DECISION DOCUMENT

TWENTY-TWO NO FURTHER ACTION SITES

**SEAD 1, 2, 7, 10, 18, 19, 20, 21, 22, 29, 30, 31, 32,
35, 36, 37, 42, 49, 55, 60, 61, and 65**

Response to Comments
by
US Environmental Protection Agency, Region 2
for Draft Decision Document
Twenty-Six Low/No Further Action Sites
SEAD 1, 2, 7, 10, 18, 19, 20, 21, 22, 29, 30, 31, 32, 35,
36, 37, 42, 47, 49, 51, 53, 55, 60, 61, 65, 70 and 72
Seneca Army Depot Activity
Romulus, New York
May 17, 2001

FIGURE 2-1

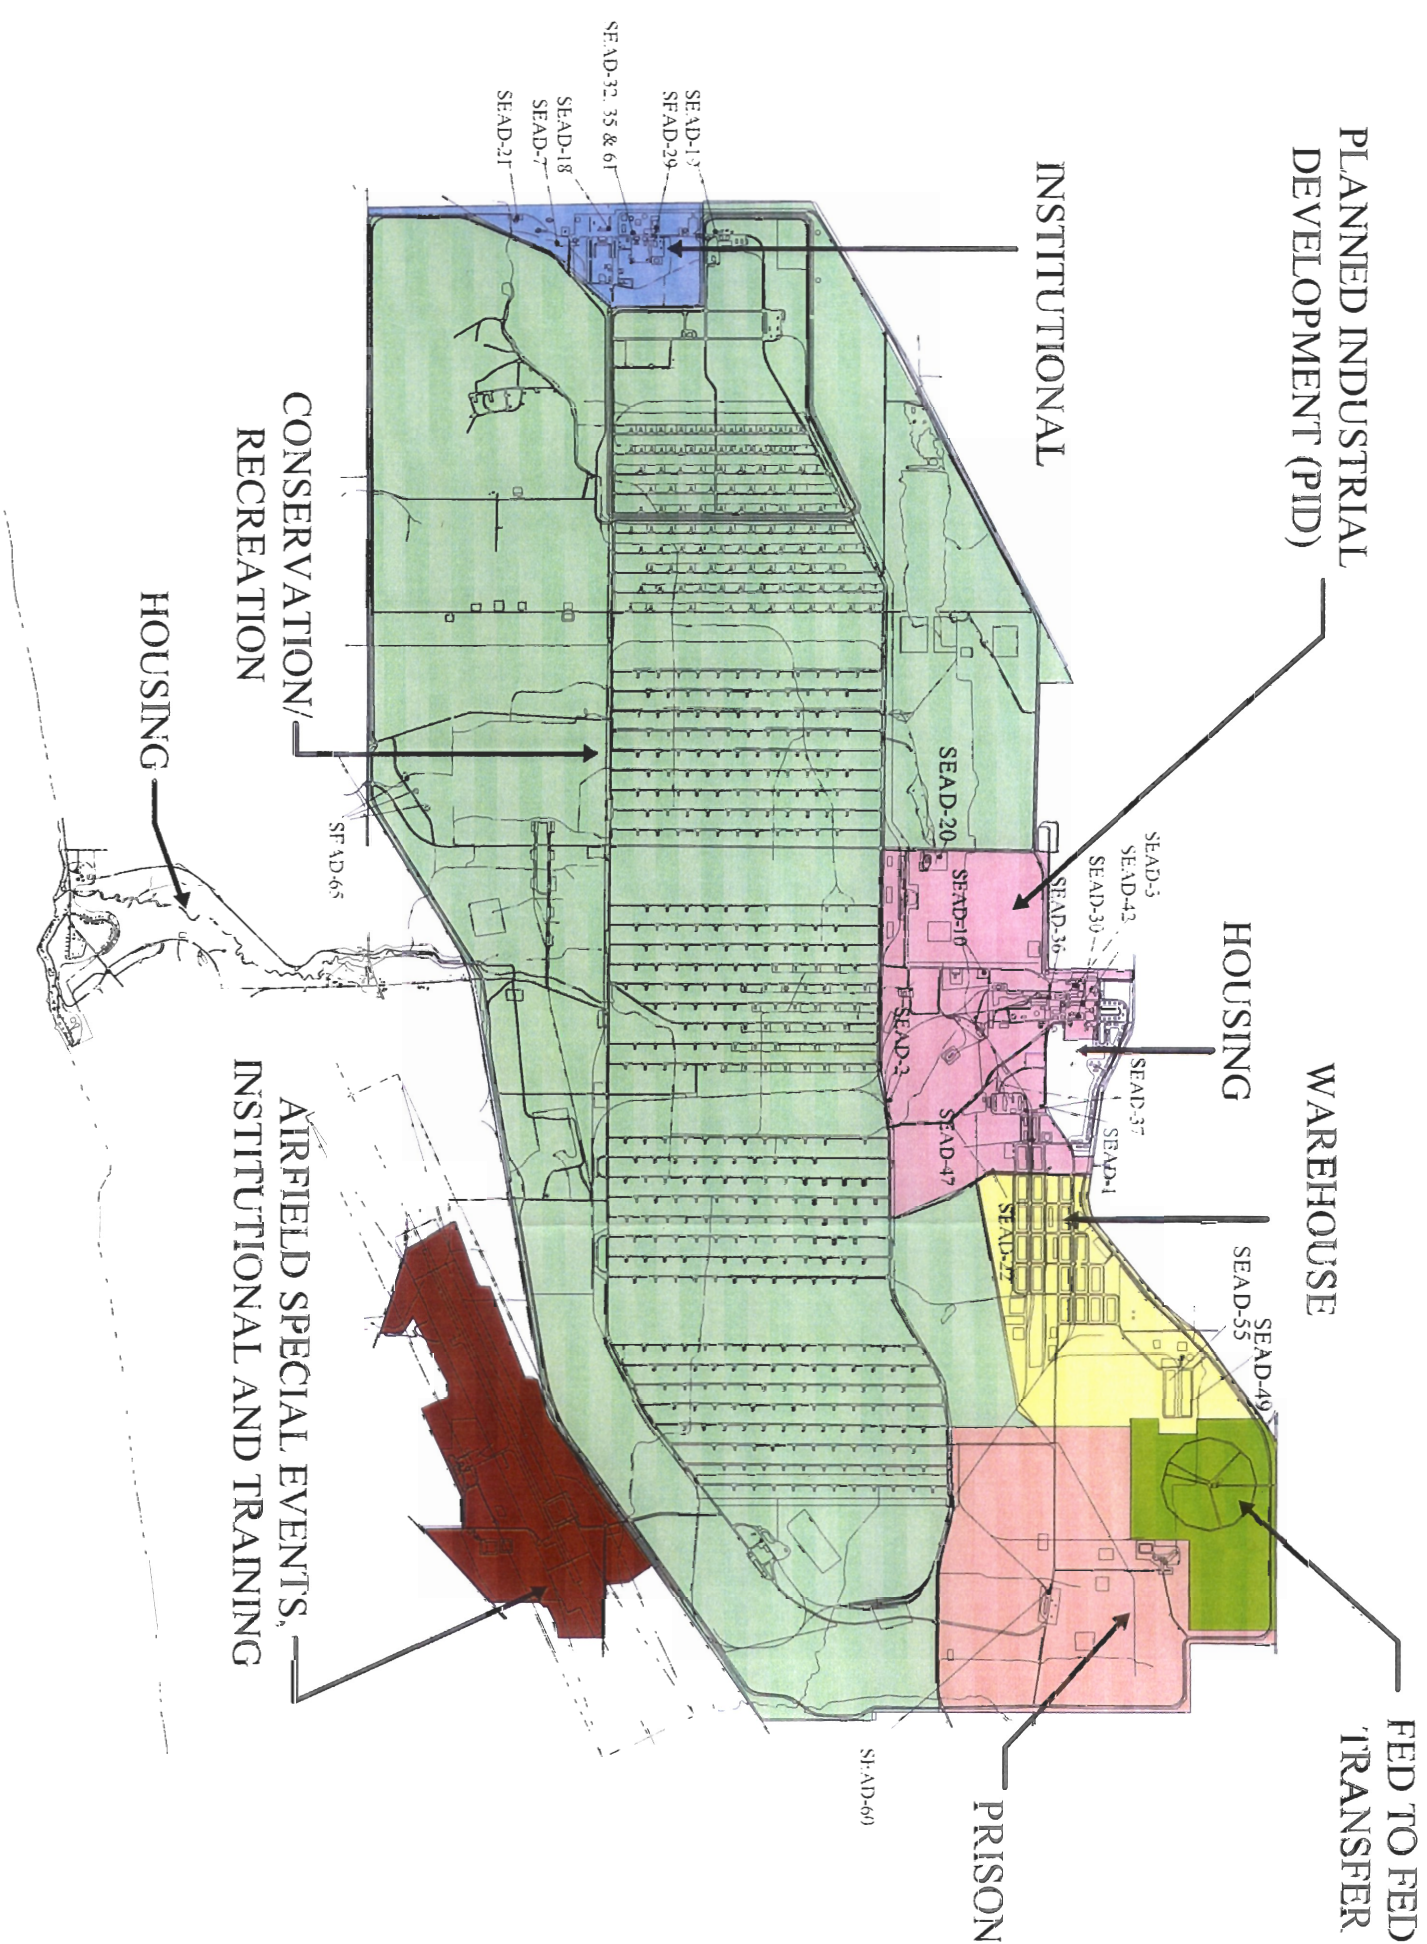
1. There seems to be a typographical error on the number for the first figure of Chapter 2. Referenced Figure 2-1 cannot be found in the document. Please include more specific maps for the different areas (i.e., North End, PID, Warehouse, Q, etc.).

Agree. The typographical error has been corrected. Additional figures are being added to the document per your request.

**PLAN VIEW OF BUILDING 106
 MEDICAL - DENTAL CLINIC**

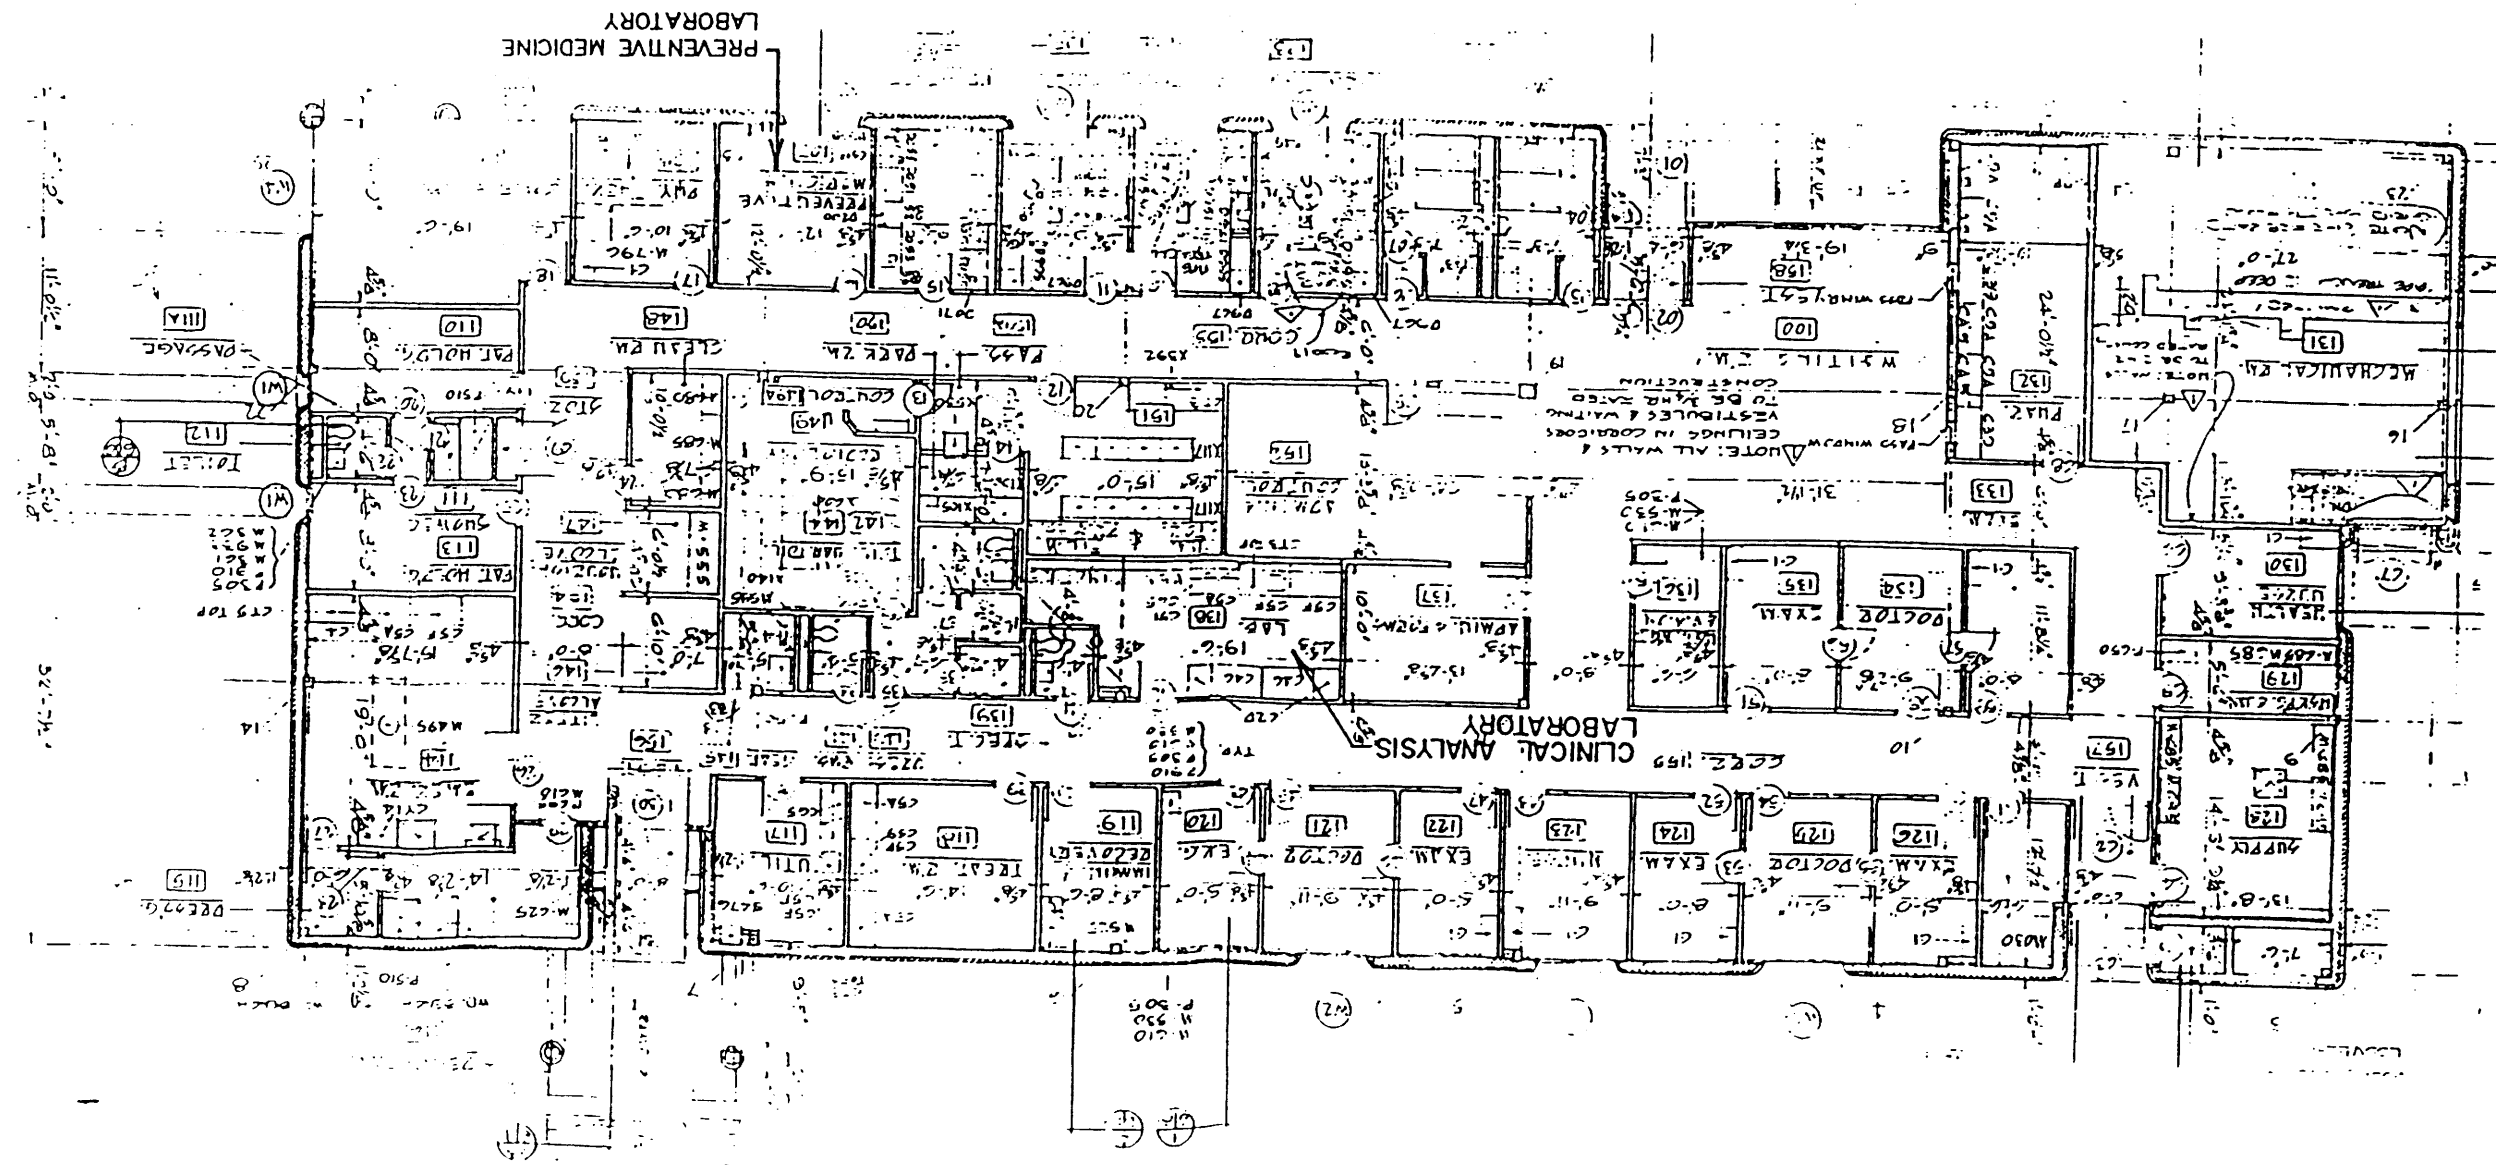
Page 2-26, Section 2.17.2: According to Figure 2-5, the Preventative Maintenance Laboratory was located in the northwest portion of Building 106, not the northeast, as indicated in the text in this section. The Clinical Analyses laboratory would then be located southeast of the Preventative Maintenance Laboratory.
